Permit Number 2021-P-1311-FP  
Job Address: FM 973 and Blake Manor Road, Manor, TX. 78653

The first submittal of the Lagos Phase 4 and 5 Final Plat (*Final Plat*) submitted by Kimley-Horn and received on July 21, 2021, have been reviewed for compliance with the City of Manor Subdivision Ordinance 263B.

**RE: 2020-P-1311-FP  
Lagos Phase 4 and 5 Final Plat  
FM 973 & Blake Manor Road, Manor, TX 78653**

Sheet 1:

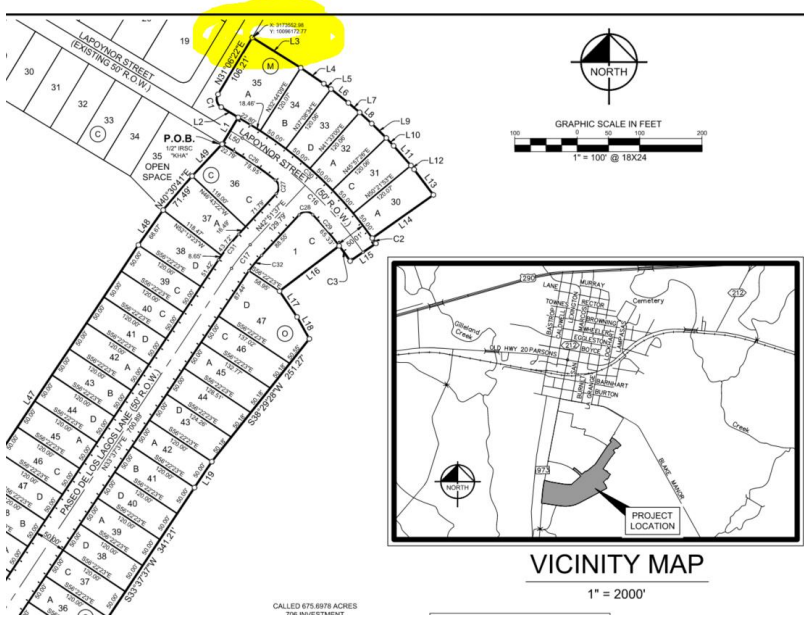
11. X and Y coordinates shall be identified for four (4) property corners on the final plat.

**Response: Please see sheets 1 and 3 of the updated plat, snip-its have been pasted below to help locate the X and Y coordinates on the plat.**

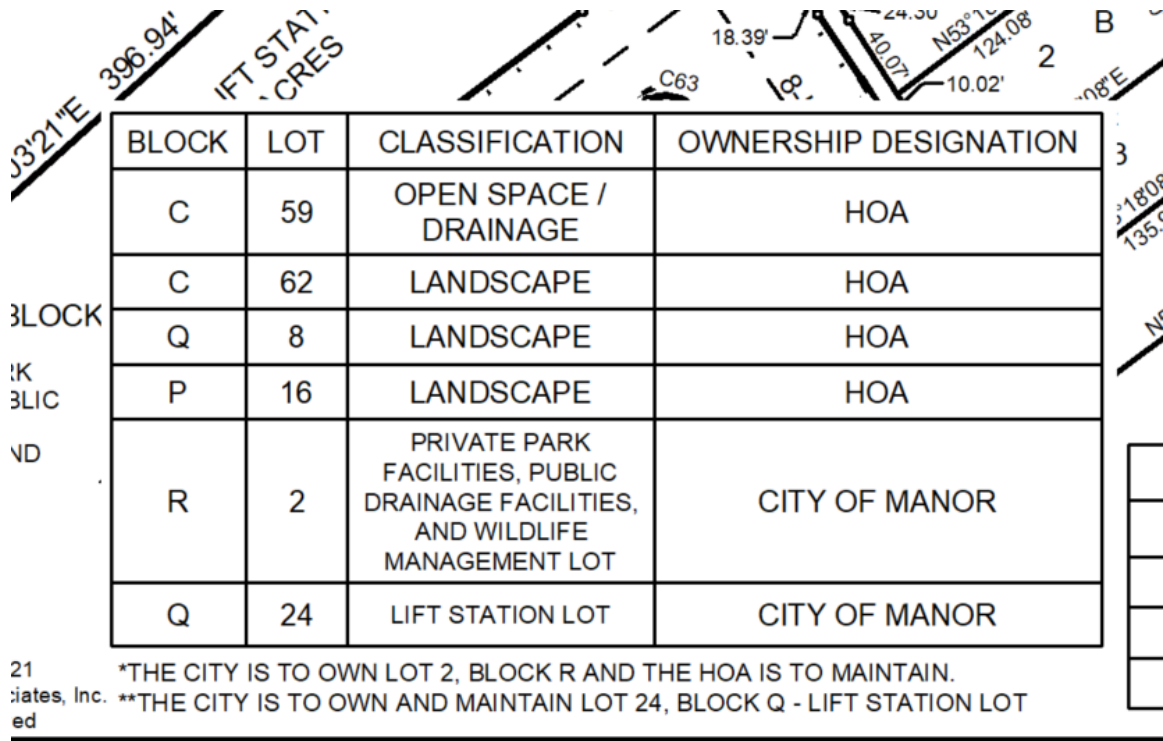
14. Provide the ownership designation for Lot 24 Block Q – Lift Station lot. Is the proposed lot going to be dedicated to the City?

15. Provide the ownership designation for Lot 2, Block R.

**Response: Please see the ownership designation table on Sheet 1, the proposed lift station lot is going to be dedicated to the city.**

**Response: Please see the ownership designation table on Sheet 1.**
